APPLICATION NO.	FILING DATE	FIRST NAMED INVENTOR	ATTORNEY DOCKET NO.	CONFIRMATION NO.
10/073,770	02/11/2002	Tsuneo Watabe	CM-131	4514

Office Action Summary

DETAILED ACTION

FIG. 13

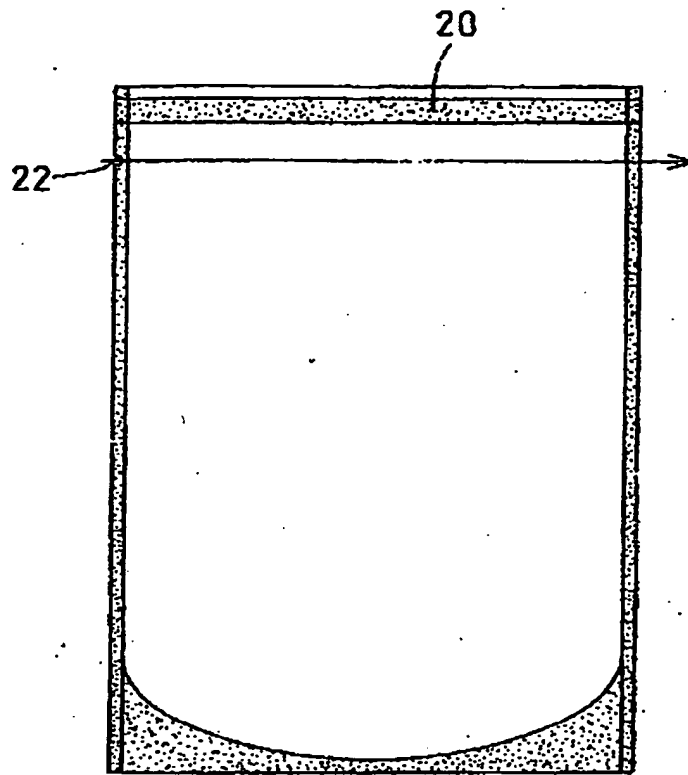
Please label Figures 13 and 14 with the legend "Prior Art". These figures are discussed in the "Description of the Related Art" section of the present application at page 3, lines 13 through 19. Each of these figures is referred to at lines 21 through 23 at page 15 in the specification as a "conventional example".

Approved for entry.
In 08-15-05
